CHARTER TOWNSHIP OF VAN BUREN
PLANNING COMMISSION AGENDA
Wednesday, August 24th, 2022 – 5:30 PM
Van Buren Township Hall
46425 Tyler Road

ITEM # 1 **Case 21-021- General Development Company, LLC – Final Site Plan**

TO: Van Buren Township Planning Commission
FROM: Dan Power– Director of Planning and Economic Development
RE: Case 21-021: General Development Company, LLC / Kenworth / CSM Companies, Inc. – Final Site Plan Review
DATE: August 18, 2022

Subject: VBT-21-021; SPR/SLU, Kenworth / CMS / I-94 N. Service Dr.; Site Plan Review #4 (FINAL); Revised Site Plans Dated July 14, 2022.

EAST ELEVATION
SCALE: 1/8" = 1'-0"

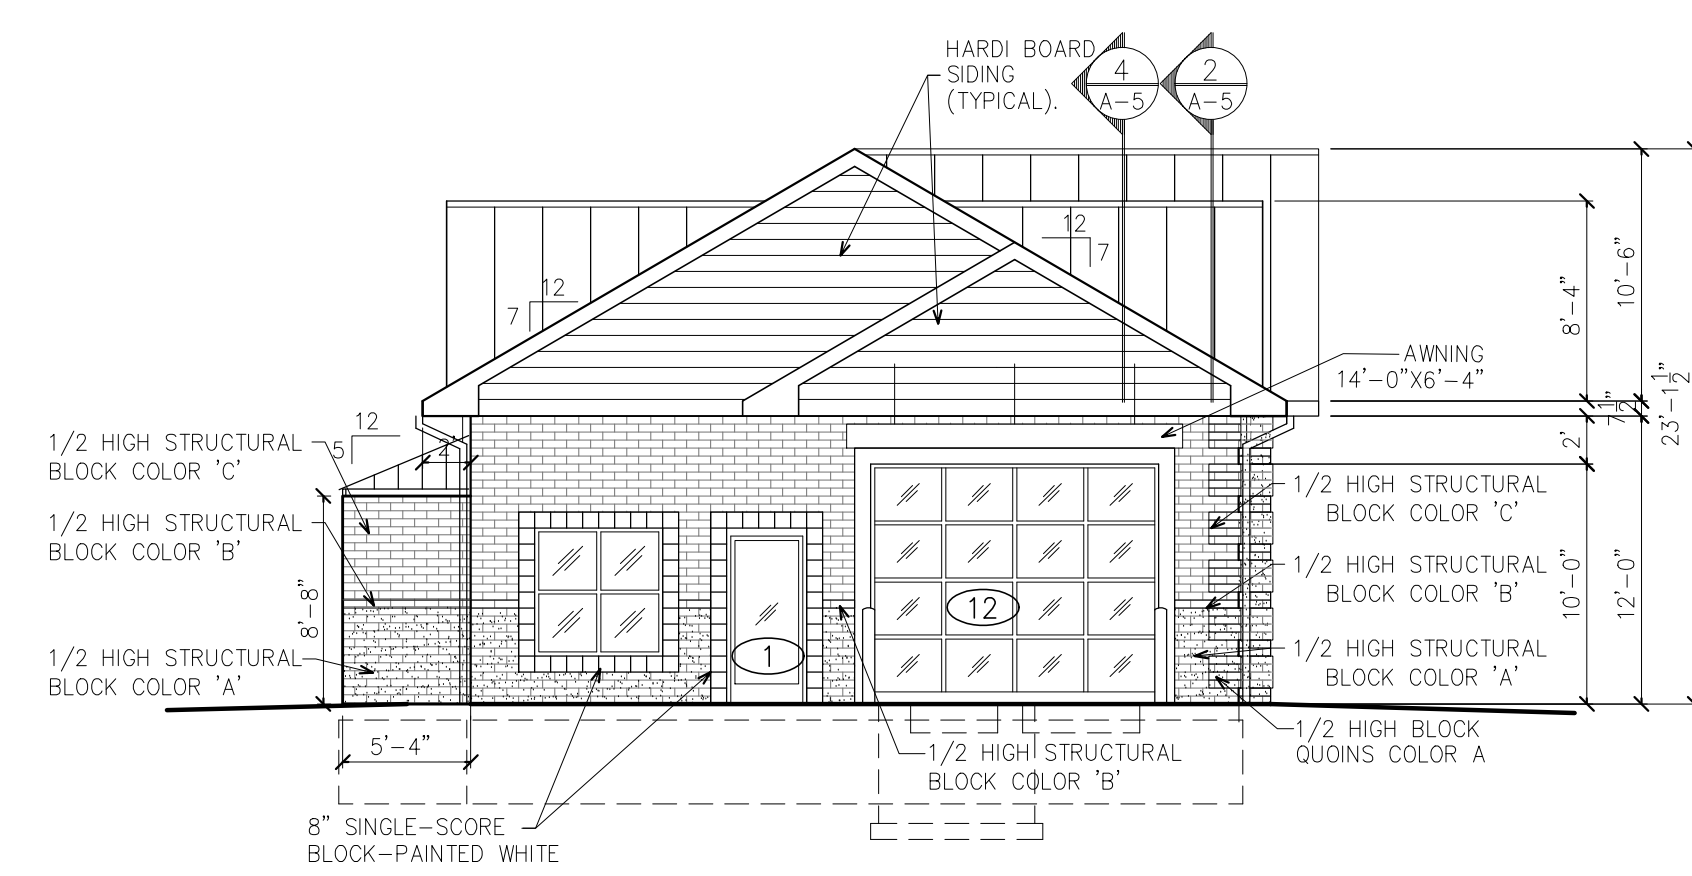
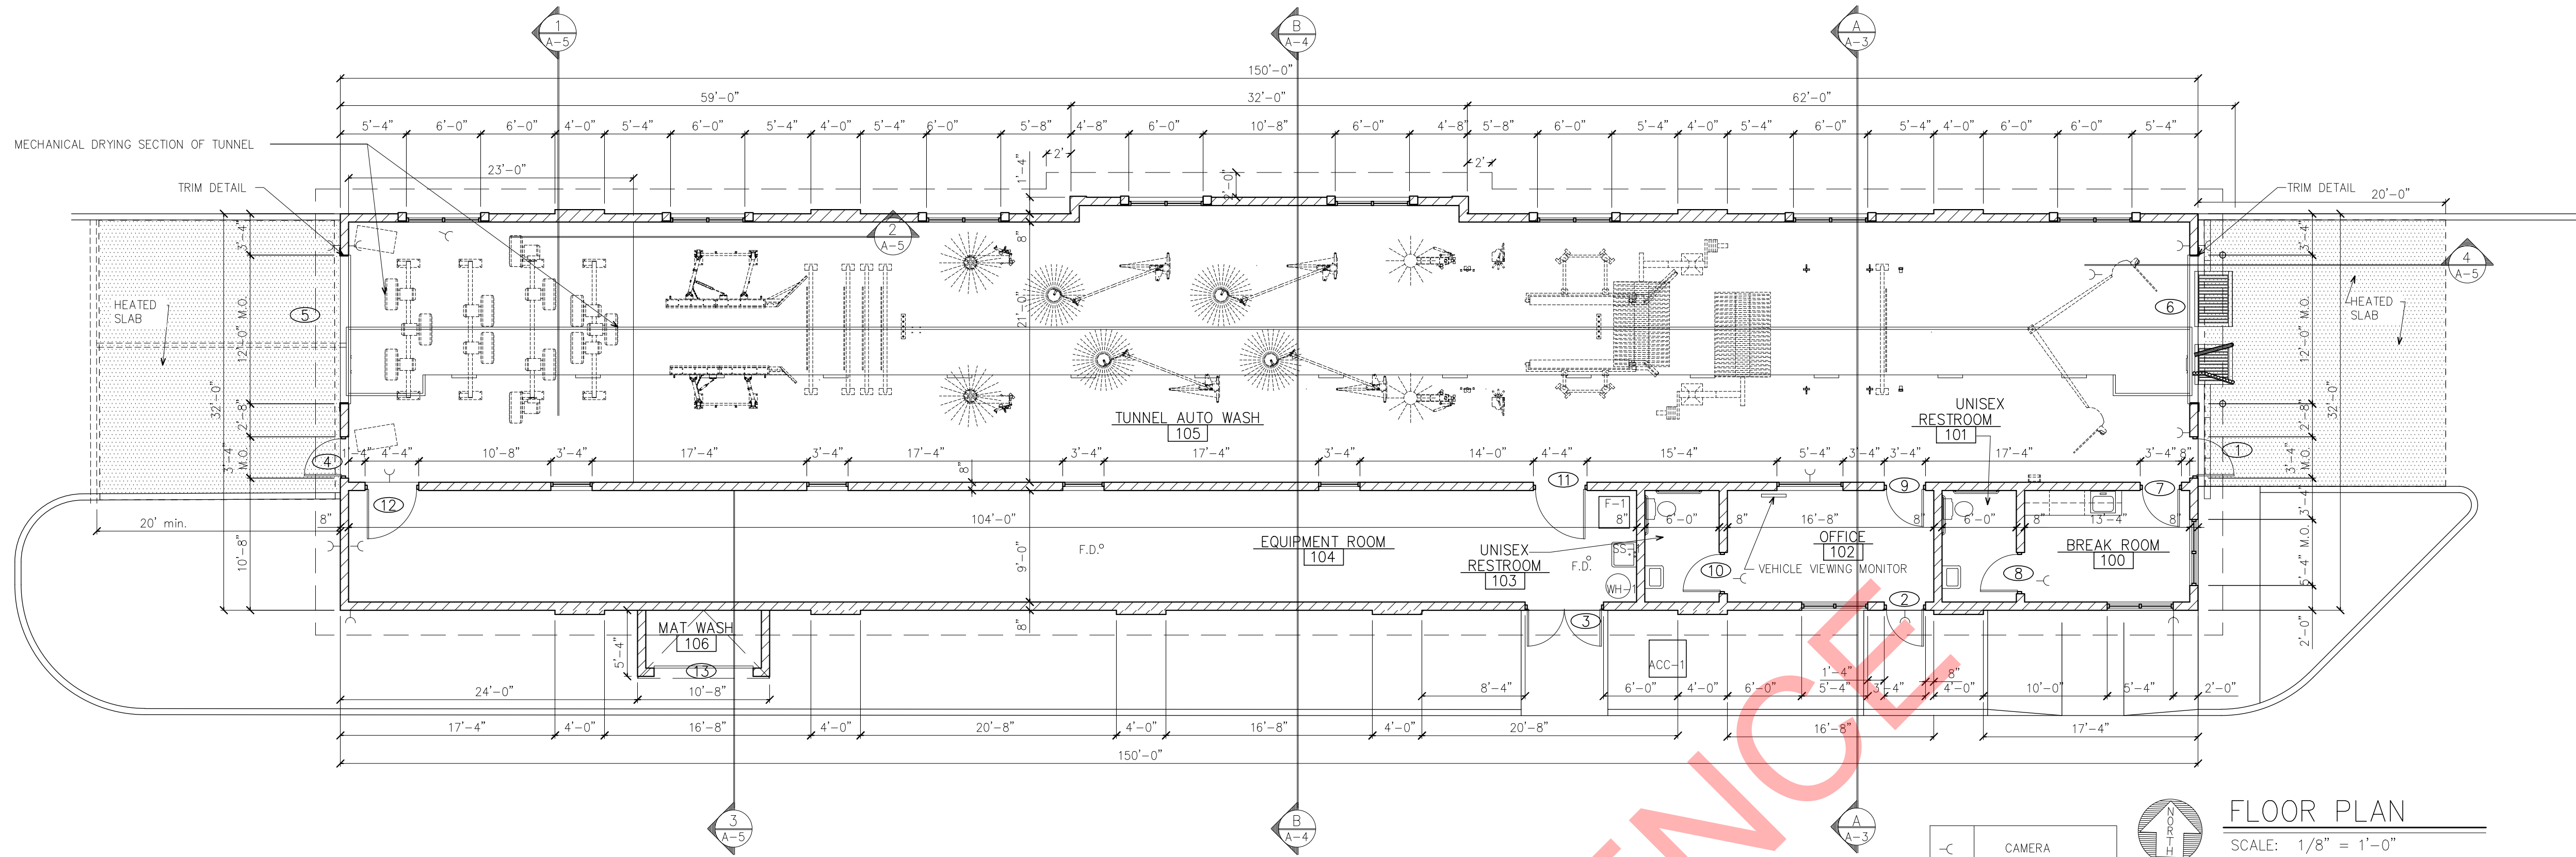
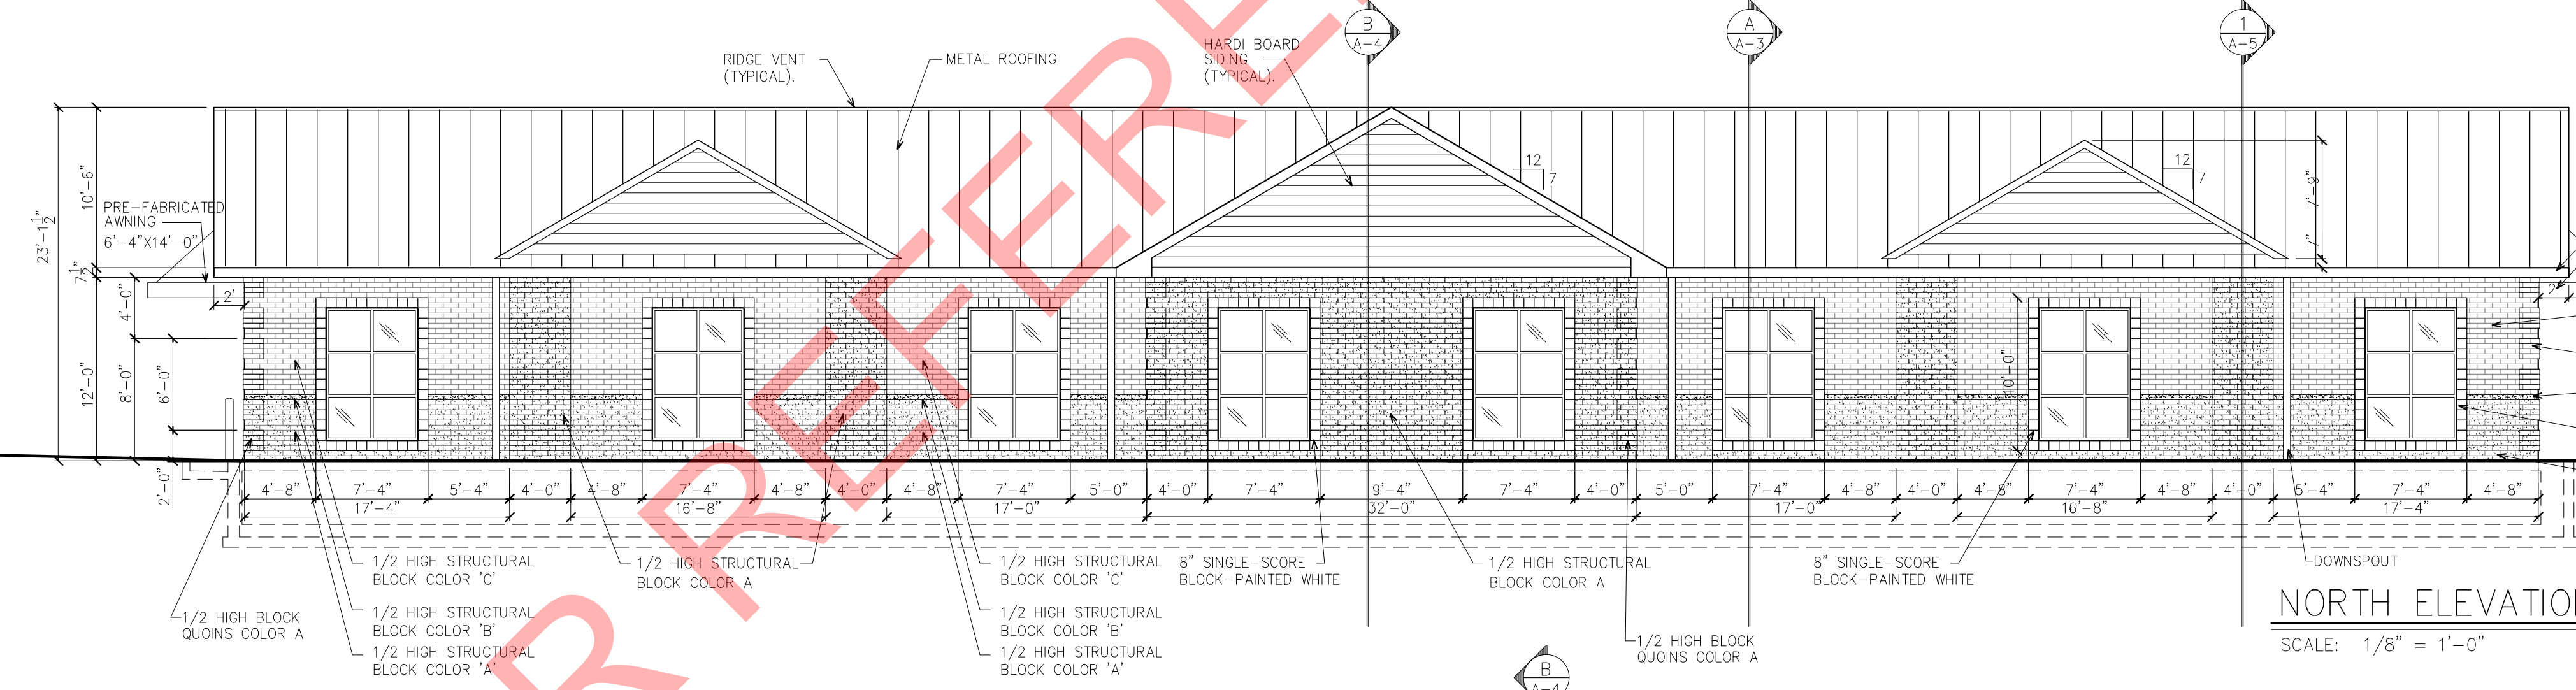
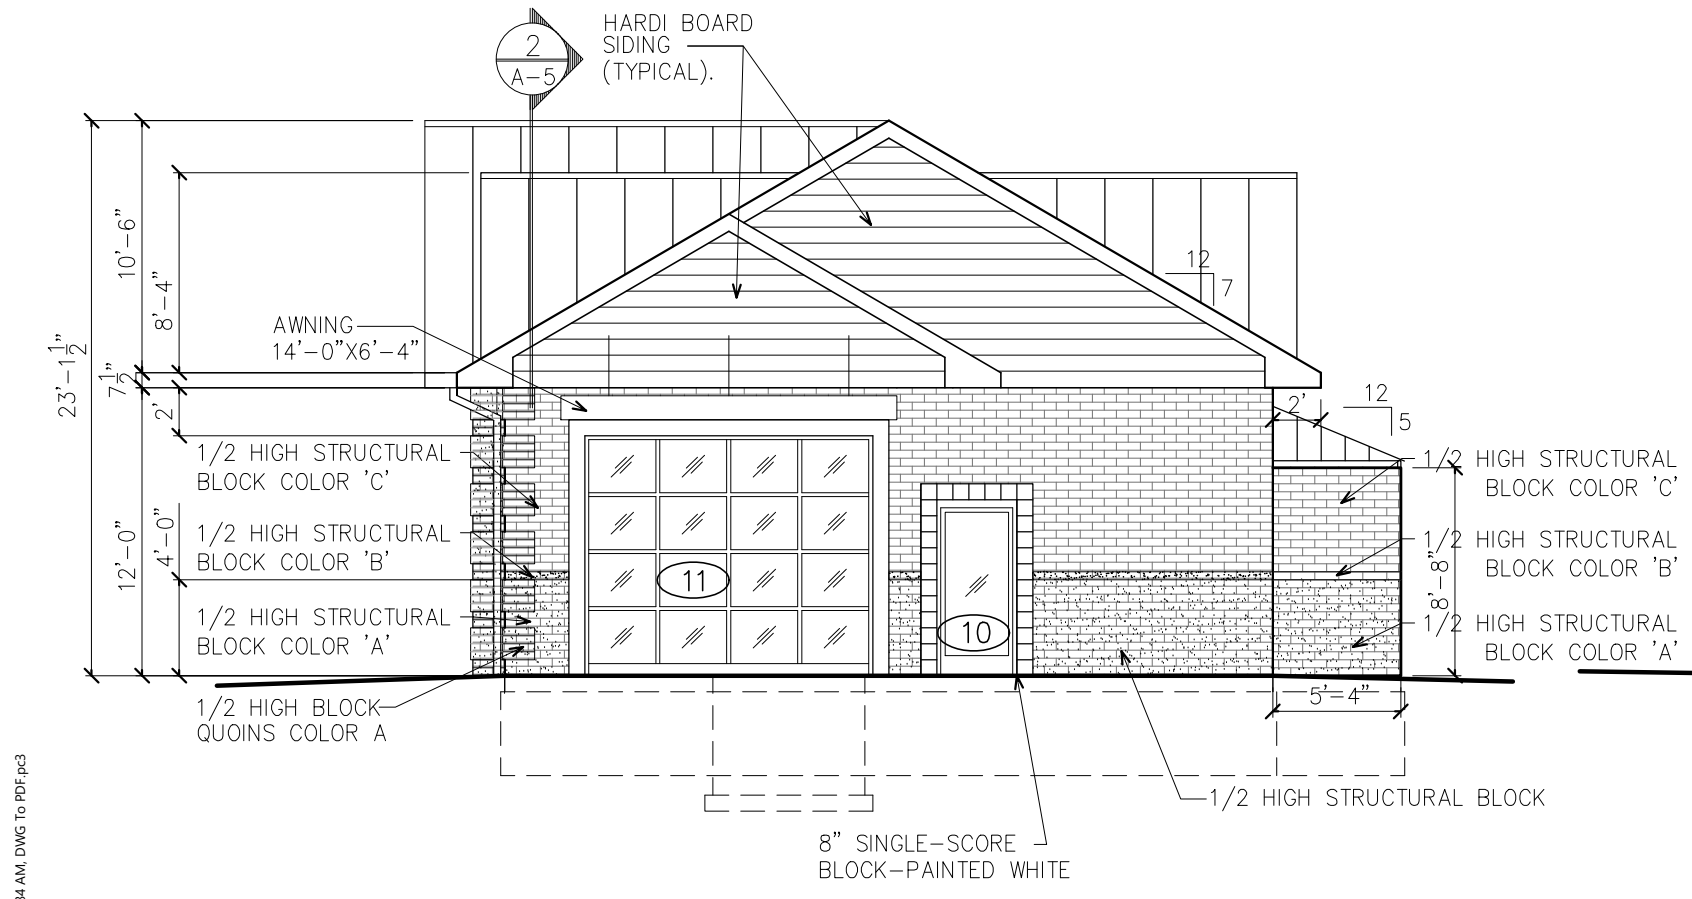
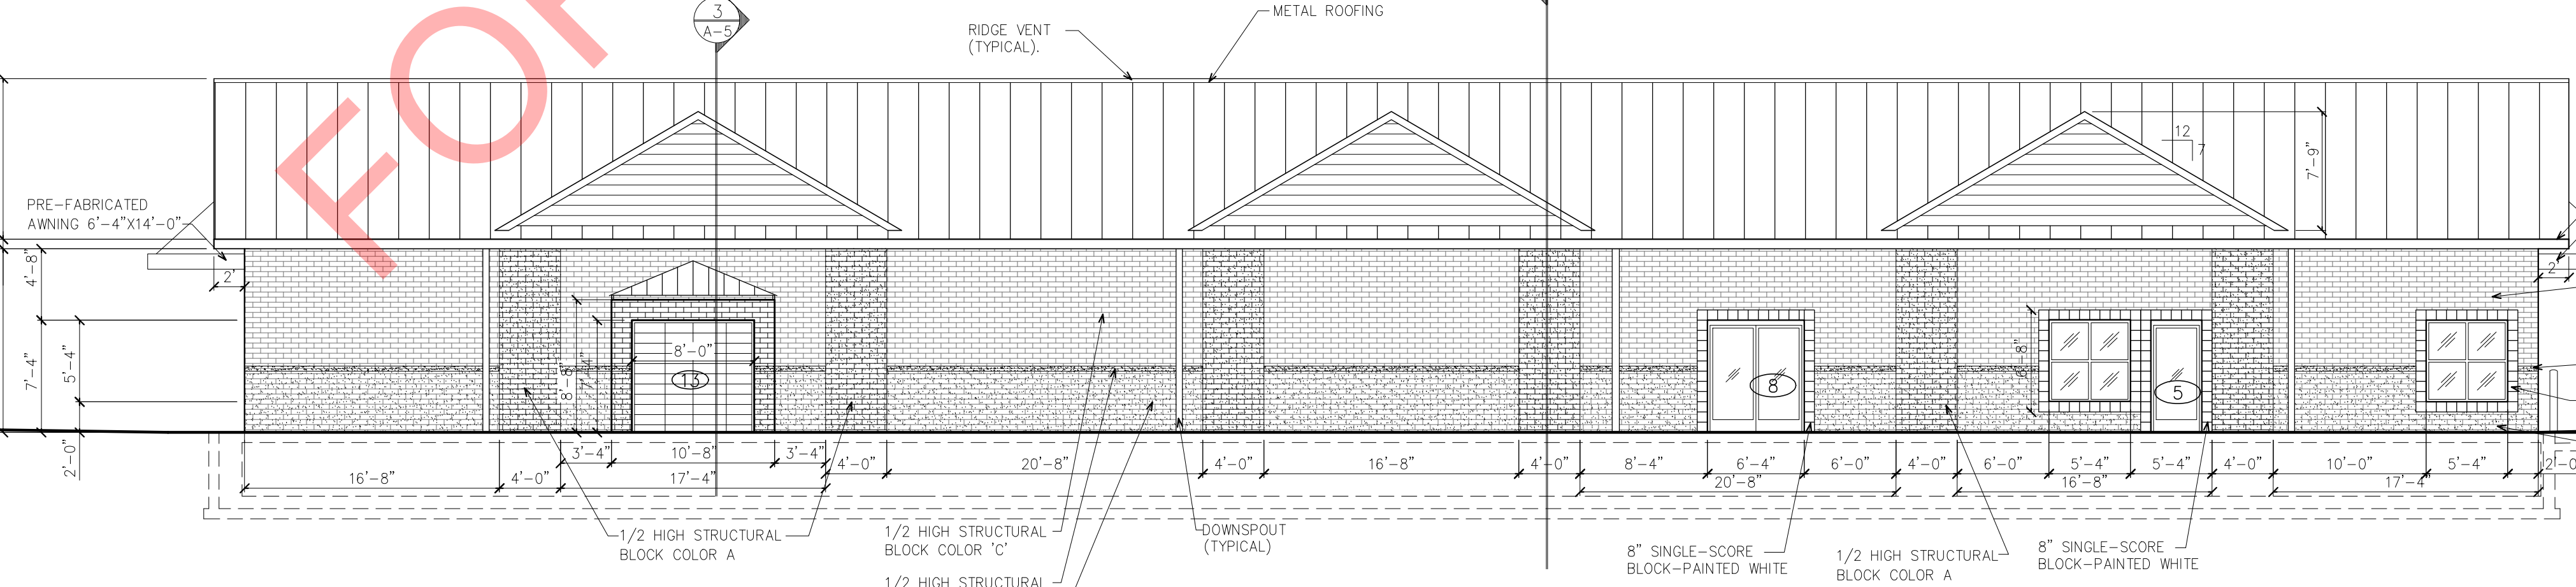
Section 6.309.C.3c of the zoning ordinance requires the first floor facade to be 50% glass when facing a public street within the BROD district.

We are seeking a variance to reduce the requirement from 50% glass to 23% glass, with the balance being premium masonry materials enhanced with a diversity of architectural features. We seek to meet the intent of the ordinance, while providing the best curb-side appearance from the outside, and the best customer experience from the inside.
